**SSHAC Level 2 Questionnaire in Support of Cuba  
Hazard Sensitivity Calculations**

**NRC RAI Letter No. PTN-RAI-LTR-041**

Proposed Turkey Point Units 6 and 7  
Docket Nos. 52-040 and 52-041  
FPL Response to NRC RAI No. 02.05.01-22 (eRAI 6024)  
L-2013-236 Attachment 18 Page 15 of 15

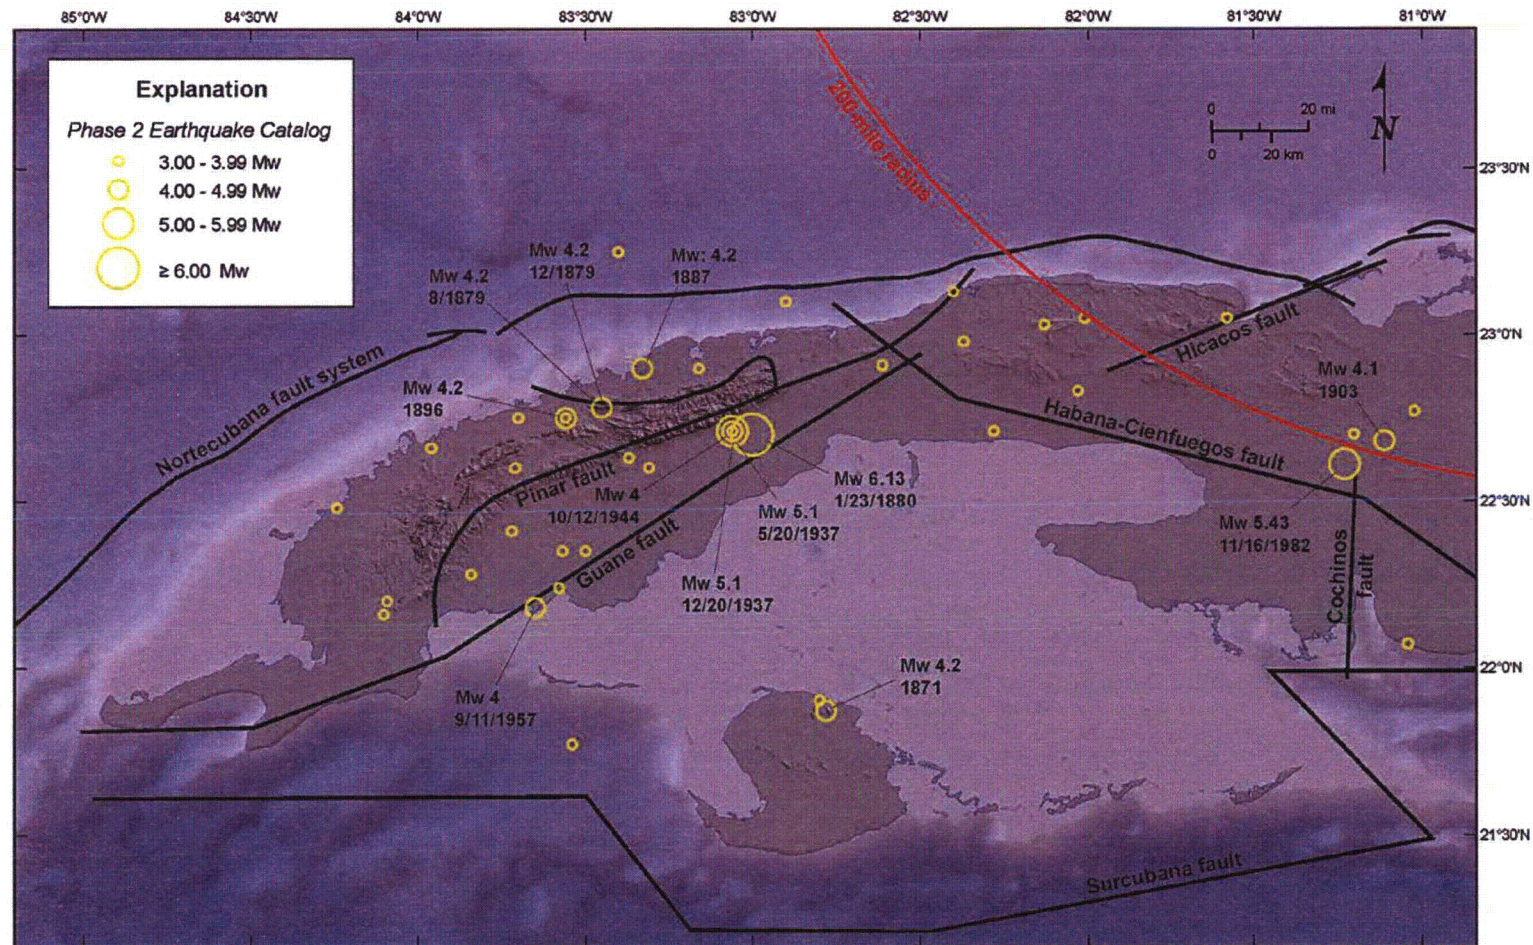
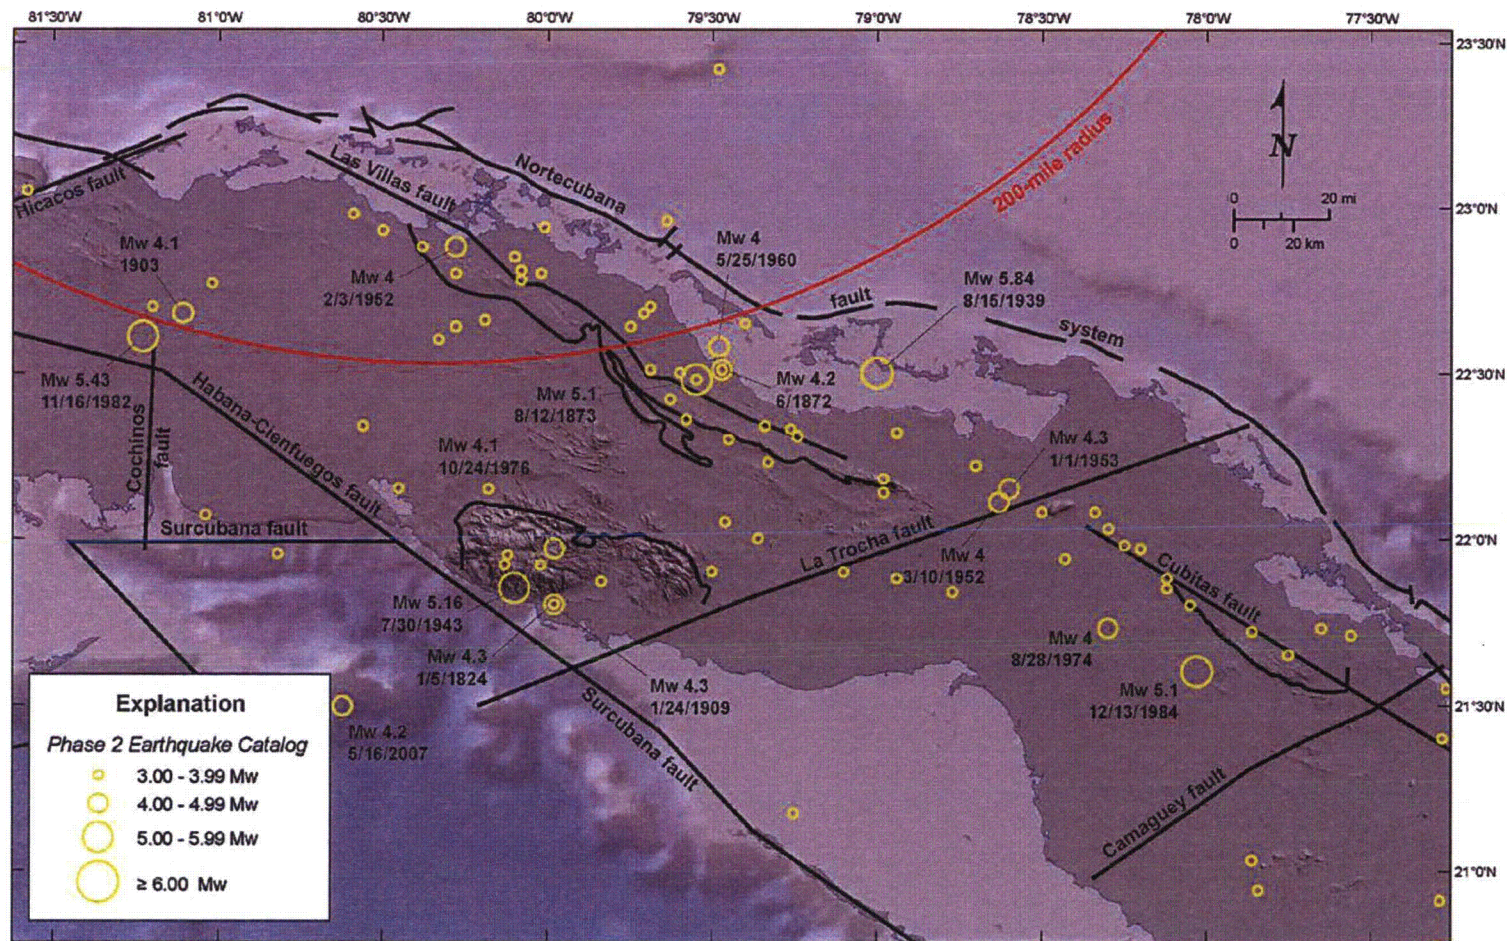
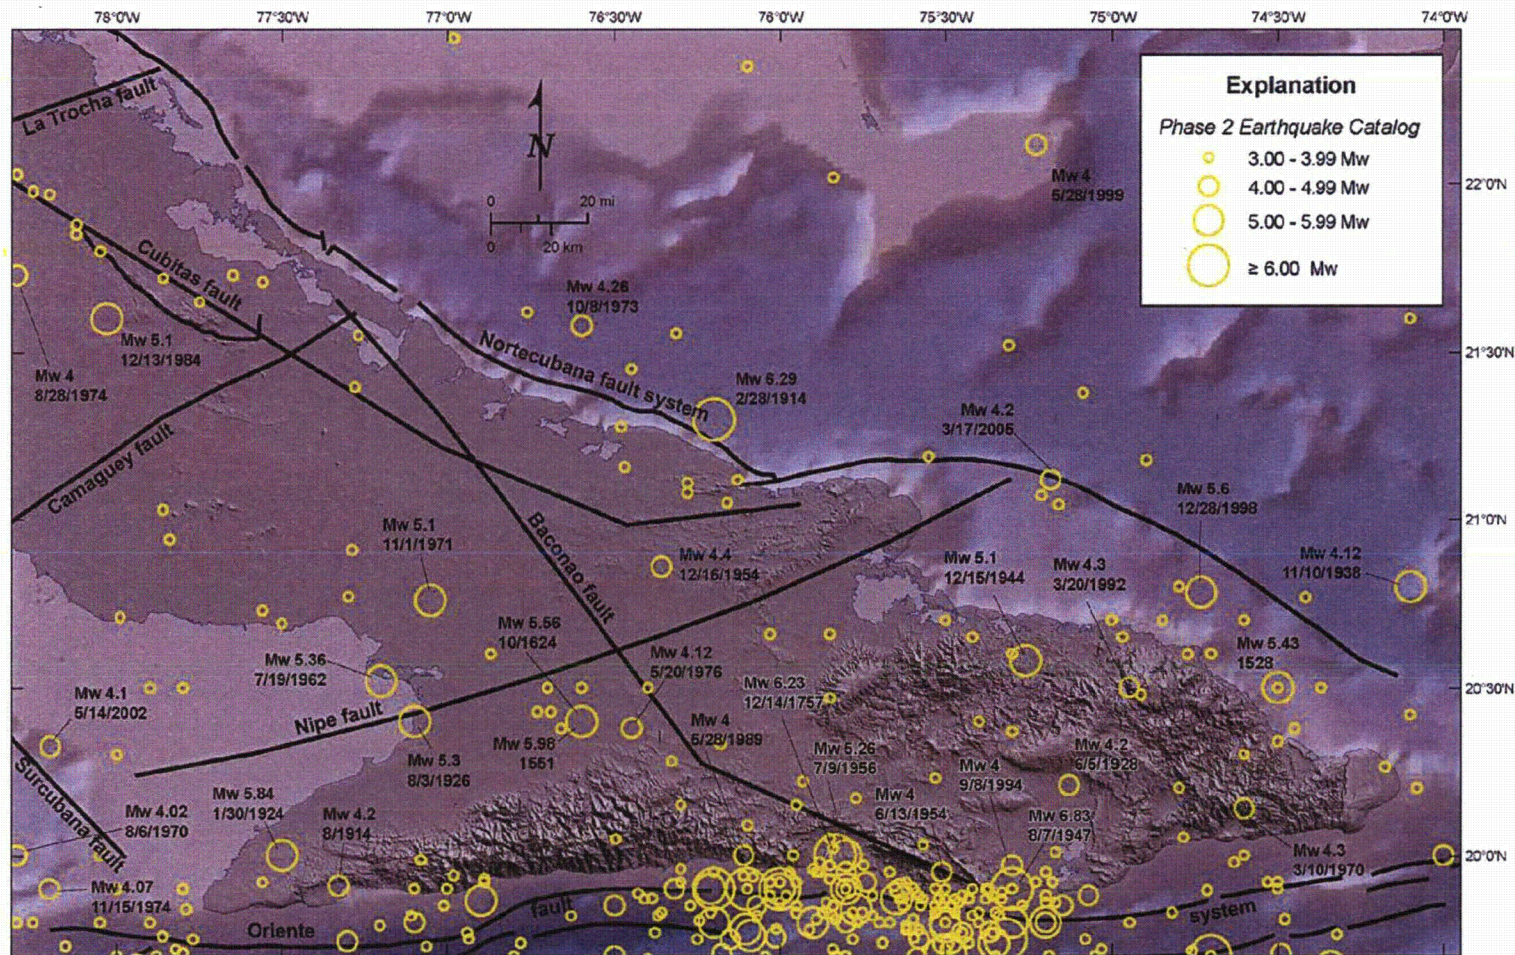
- a) Identify the Nortecubana fault or faults on seismic reflection sections and provide a map showing the surface trace or projection of the Nortecubana fault or faults with respect to topography and bathymetry.

- d) Discuss the February 1914 (Mw 6.2) earthquake offshore northeastern Cuba near the Nortecubana fault in light of the FSAR Section 2.5.1.1.1.3.2.4 that states that "there is no direct evidence that these earthquakes occurred on the Pinar and Nortecubana Faults". Please clarify what direct evidence is required to establish a connection between the earthquake and the faults.

Figures 1A, 1B, and 1C show the surface projection of the Nortecubana fault as mapped by French and Schenk (2008) (FSAR Subsection 2.5.1, Reference 492) on a shaded-relief map. Additionally, FSAR Figures 2.5.1-202 and 2.5.1-229 plot the approximate location of the Nortecubana fault on shaded-relief maps.

According to the Phase 2 earthquake catalog, a  $M_w$  6.29 earthquake occurred on February 28, 1914, off the northeastern coast of Cuba (Figure 1C). The direct evidence required to establish a connection between an earthquake and a given fault would include at least one of the following:

Figure 2 Escarpments and Postulated Faults in the Southern Straits of Florida from Malloy and Hurley (1970)

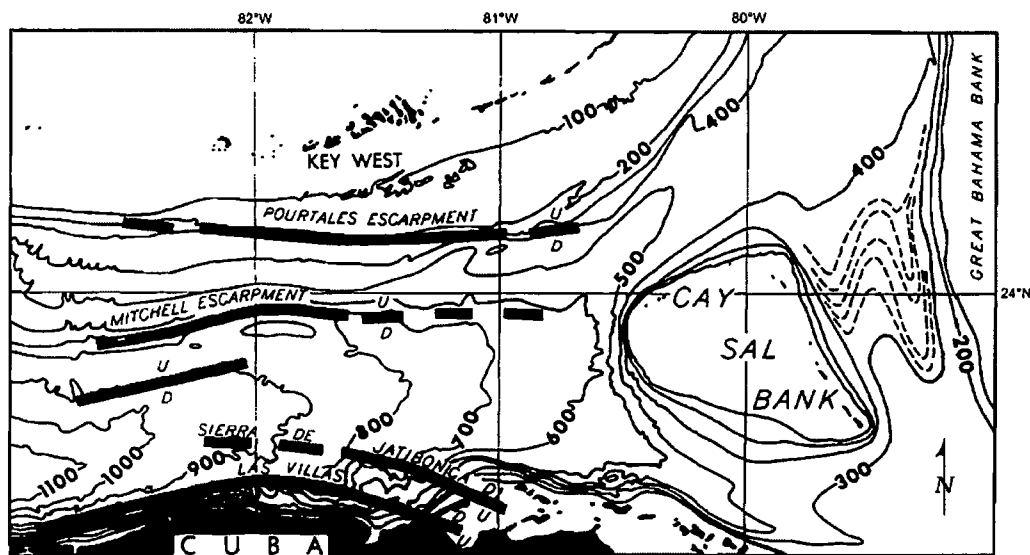
- b) Clarify the relationship between the Nortecubana fault system and the Cuban Fold and Thrust Belt.
- c) The FSAR states "Cotilla-Rodríguez et al. (Reference 494) indicate that the Nortecubana Fault Trench is expressed in the bathymetry north of Cuba, but this does not constitute direct evidence for activity." Please clarify what processes give rise to a bathymetric expression of an inactive fault in a sedimentary basin.

Other studies suggest the possibility that the Nortecubana fault may be expressed in the bathymetry, but these studies do not provide detailed descriptions of the nature of this possible bathymetric expression. Malloy and Hurley's (1970) depiction of the offshore Las Villas fault extends for approximately 120 miles (200 kilometers) roughly from Matanzas Bay westward to Havana (Figure 2) and is nearly coincident with more recent depictions of the Nortecubana fault in that region (e.g., Cotilla-Rodriguez et al. (2007) [FSAR Subsection 2.5.1, Reference 494], French and Schenk 2008 [FSAR Subsection 2.5.1, Reference 492]) (Figure 1A). Due to this spatial coincidence, it is assumed that Malloy and Hurley's (1970) offshore Las Villas fault is the same structure as that portion of the Nortecubana fault as depicted in more recent literature (e.g., Cotilla-Rodriguez et al. [2007] [FSAR Subsection 2.5.1, Reference 494], French and Schenk 2008 [FSAR Subsection 2.5.1, Reference 492]). Malloy and Hurley (1970, p. 1962) provide only a very limited description of the offshore Las Villas fault and state that it "appears to be reflected in the bathymetry as a scarp" and that this bathymetric expression is "due presumably to faulting." Malloy and Hurley (1970) do not provide any description of scarp dimensions, including length, height, and continuity, and therefore, it is not clear whether their use of the term "scarp" refers to gross features in the bathymetry like the slope break north of Cuba or more localized features. Moreover, they do not explore alternate explanations that include possible submarine slumping along the continental slope and submarine erosion associated with currents and low sea level stands, as has been proposed for other bathymetric features within the Straits of Florida (e.g., Mullins and Newman 1979).

**Figure 2.5.1-279 Offshore Cross Section across the Cuban Fold-and-Thrust Belt, Western Cuba**

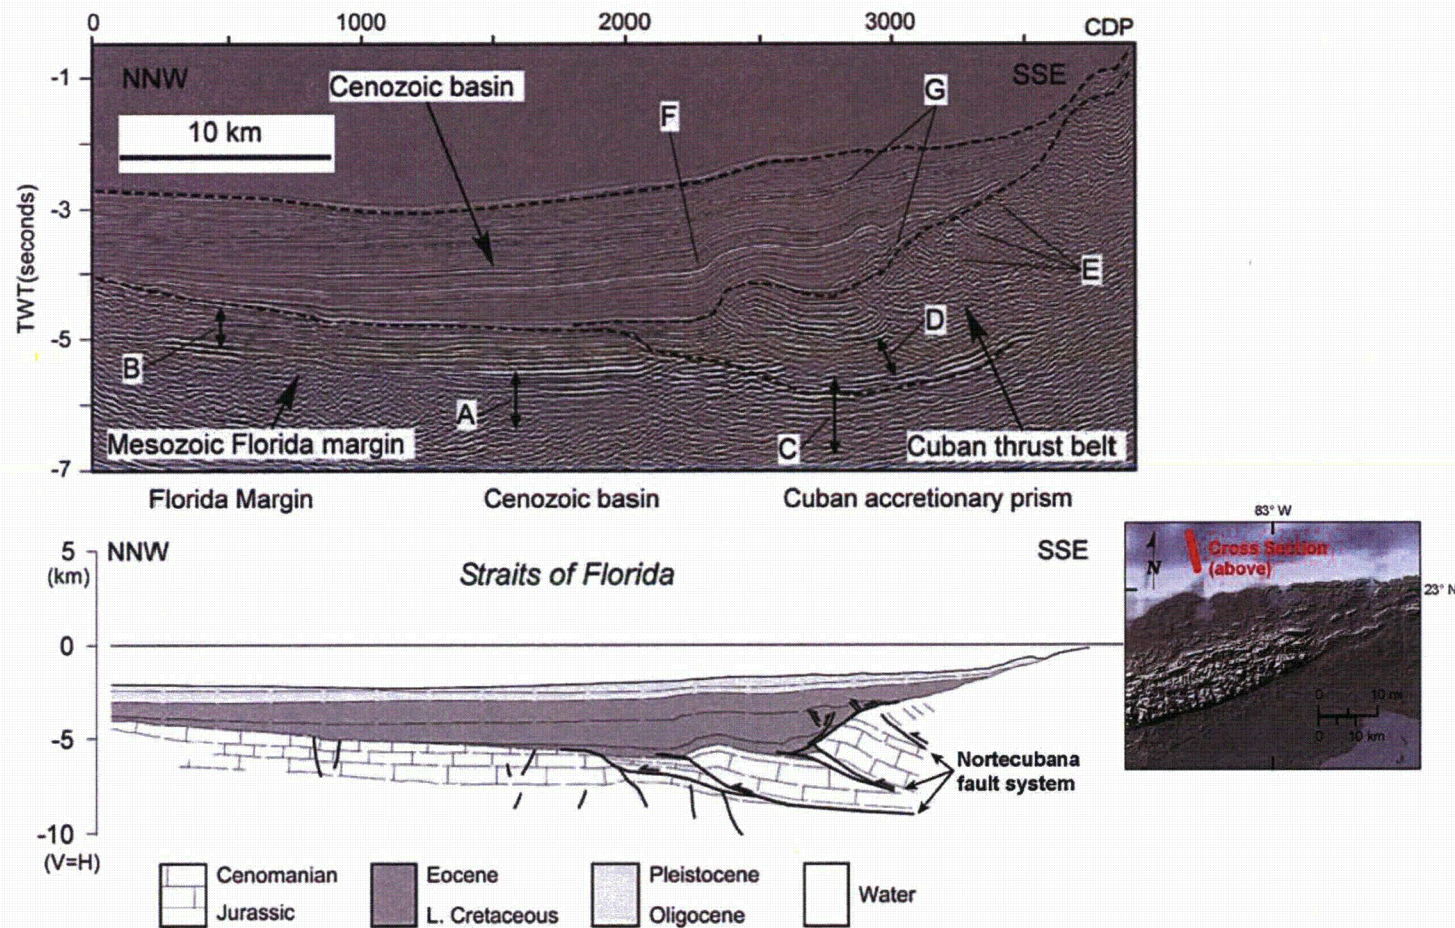
- a) Discuss the tectonic implications of the seismic reflection features above the mapped faults for Plio-Pleistocene activity in the Cuban Fold and thrust belt.
- b) Clarify how the unfaulted and uplifted Pleistocene marine terraces demonstrate a lack of capable tectonic feature.
- c) Discuss the suitability of using the schematic diagram (FSAR Figure 2.5.1-282) to conclude that faults of the Cuban Fold-and-Thrust Belt are Tertiary in age and not capable tectonic structures.

FSAR Figure 2.5.1-279 is modified slightly after Saura et al.'s (2008) (FSAR Reference 485) Figure 8, which shows: (a) an annotated seismic reflection profile from the Straits of Florida offshore north of Cuba and (b) a geologic cross section interpreted from this seismic reflection profile. According to Saura et al. (2008) (FSAR Reference 485, p. 12), the dashed lines shown in their panel (a) (and reproduced in the upper panel of FSAR Figure 2.5.1-279) represent "approximate boundaries between the main domains." In this upper panel, reflectors within the Cuban thrust belt domain appear as faulted and deformed. This deformation continues upward into the Cenozoic basin domain. Visible irregularities in the Oligocene and Pleistocene reflectors in the seismic profile are discussed by Saura et al. (2008) (FSAR Reference 485, p. 12) as "bright, irregular, internally chaotic reflections above the front of the Cuban thrust belt," which are typical of the Cenozoic section in this area (seismic unit G in Saura et al.'s [2008] [FSAR Reference 485] Figure 8a). Saura et al.

Saura et al.'s (2008) (FSAR Reference 485) panel (b) (reproduced in the lower panel of FSAR Figure 2.5.1-279) shows their interpreted geologic cross section and provides more detailed age information for the sediments. This lower panel shows that deformation and faulting associated with the Cuban thrust belt extends upward into Late Cretaceous to Eocene reflectors (dark gray) but does not appear to deform overlying Oligocene to Pleistocene reflectors (light gray). This is consistent with Saura et al.'s (2008) (FSAR Reference 485, p. 13) statement that "[the Cuban thrust belt] was a long-lived structure, which could be active at least up to late Eocene times. However, the main growth stage corresponds to the lowermost part of the sequence, which from borehole data is known to be pre-Middle Eocene." Seismic reflection lines depicted in FSAR Figures 2.5.1-280, -287, and -288 also show evidence for unfaulted late Tertiary to Quaternary sediments draping thrusts of the Nortecubana fault system, as mentioned in FSAR Subsection 2.5.1.1.1.3.2.4 (p. 2.5.1-104).

FSAR Figure 2.5.1-279 will be replaced with the revised figure shown below in a future revision of the FSAR.

Figure 1A The Phase 2 Earthquake Catalog and Faults of Western Cuba

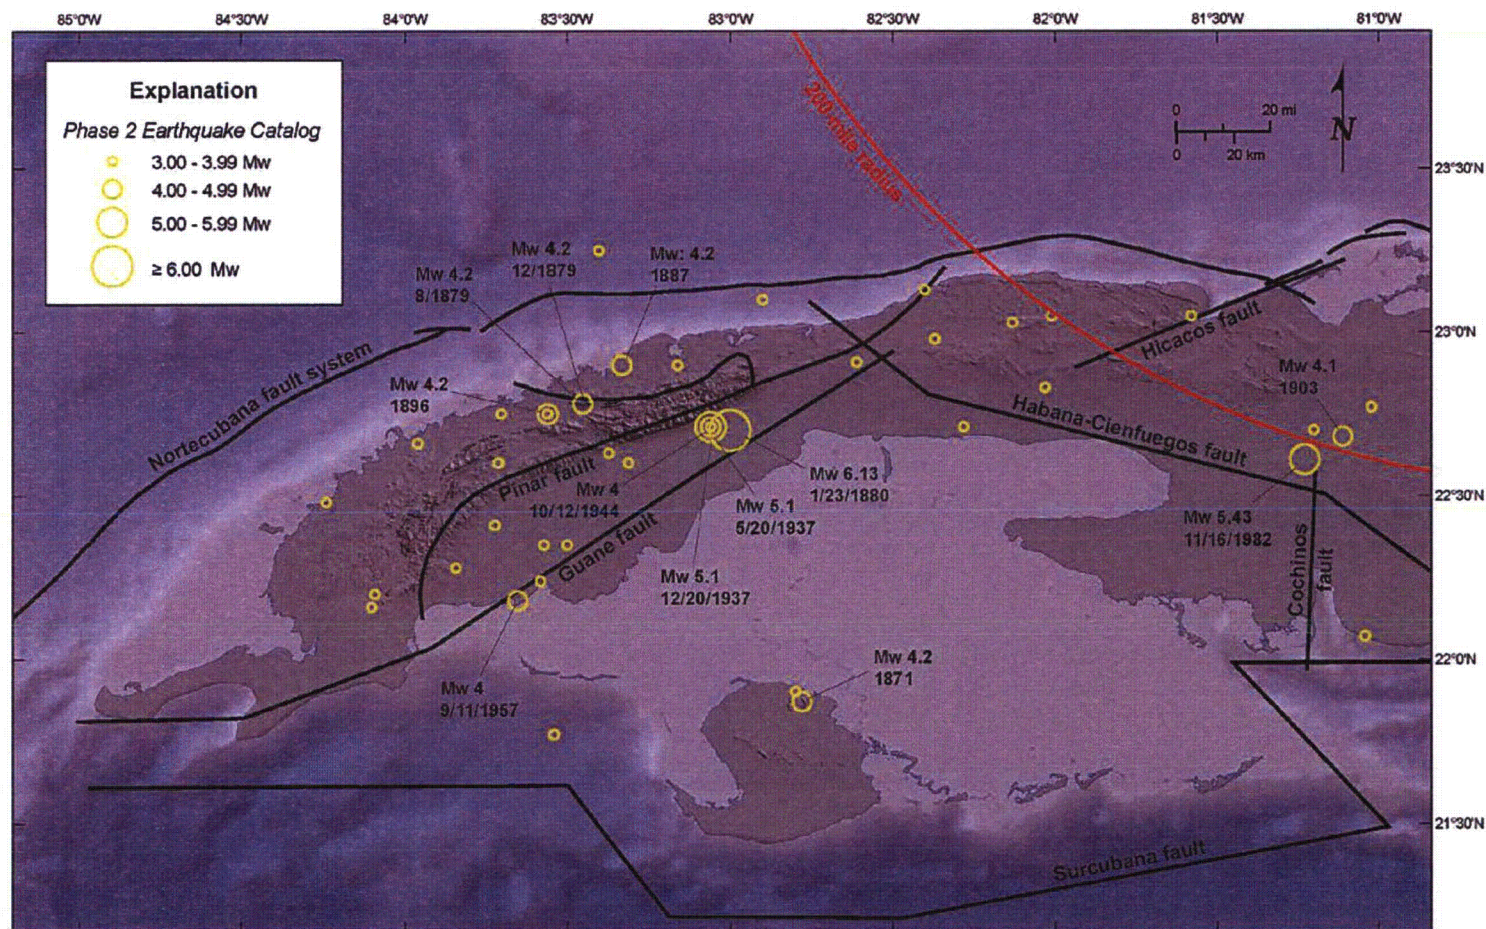
- a) Provide a map of the Hicacos fault and seismicity, including earthquake location errors, and discuss the relationship of the Hicacos fault to nearby seismicity.

Figure 1A shows epicenters from the Phase 2 earthquake catalog and faults in western Cuba, including the Hicacos fault. The Phase 2 catalog is declustered and includes earthquakes of  $M_w$  3 and above. These earthquakes include both instrumentally located earthquakes and pre-instrumental earthquakes whose locations are based on historical felt intensity reports. The accuracy of the instrument-derived earthquake locations is limited by the lack of permanent seismic recording stations in Cuba, especially for lower-magnitude earthquakes. In fact, many of the earthquake magnitudes and locations from the instrumental era are intensity-based as well, and therefore, the uncertainties in locations of Cuban earthquakes are both high and variable. The accuracy of intensity-based locations is a function of the number and reliability of felt reports, the population density and distribution, and other factors. Even for earthquakes with well-constrained intensity centers, there remains ambiguity in the location of the epicenter because of possible seismic wave

Earthquake location errors are not shown on Figure 1A because the data with which to estimate these errors for each earthquake are not available. According to Cotilla-Rodriguez et al. (2007) (FSAR 2.5.1 Reference 494, p.518), the “epicenter determination [for earthquakes] in the western, central, and central-eastern [portions of Cuba] have limitations because of scarce or no permanent seismic stations.” The accuracy of the pre-instrumental earthquakes in Cuba is limited by the fact that felt intensity reports are restricted to onshore areas and are concentrated in near-coastal areas where population density historically is greater than the interior of the island. Both of these factors potentially bias the locations of pre-instrumental earthquakes to coastal and near-shore Cuba. Regarding the locations of pre-instrumental earthquakes in Cuba, Garcia et al. (2003) (FSAR 2.5.1 Reference 489, p. 2,569) state that, “Taking into account the complexity of the Cuban tectonic environment, the poor knowledge about the kinematic evolution of the principal fault systems, and the uncertainty in the hypocentral location of historical events (uncertainty of 15-20 kilometers or more in the historical coordinates is reasonable), it is impossible to associate earthquakes with individual faults.”

Figure 1A indicates only sparse, minor-magnitude seismicity from the Phase 2 catalog near the northeast-striking Hicacos fault, described as a normal left-lateral transcurrent fault by Cotilla-Rodriguez et al. (2007) (FSAR 2.5.1 Reference 494). The nearest epicenters from the Phase 2 earthquake catalog to the Hicacos fault are four co-located  $M_w$  3.1 to 3.7 earthquakes that occurred near the central portion of the fault in 1812, 1852, 1854, and 1970. Another earthquake occurred in 1777 with  $M_w$  3.7, located on strike with, but approximately 7 miles (11 kilometers) southwest of, the mapped fault trace. Likewise, Cotilla-Rodriguez et al. (2007) (FSAR 2.5.1 Reference 494) indicate sparse seismicity near the Hicacos fault, and note that no focal mechanisms are associated with earthquakes in the vicinity of this fault. According to Cotilla-Rodriguez et al. (2007) (FSAR 2.5.1 Reference 494), historical accounts suggest 10 earthquakes of less than or equal to Medvedev-Sponheuer-Karnik (MSK) intensity V (approximately MMI V) occurred in the vicinity of the Hicacos fault (FSAR 2.5.1 Reference 494). However, the association of these earthquakes with the Hicacos fault or another mapped or unmapped fault is problematic due to the uncertainties associated with the locations of both faults and earthquakes in Cuba and the paucity of available focal plane solutions.
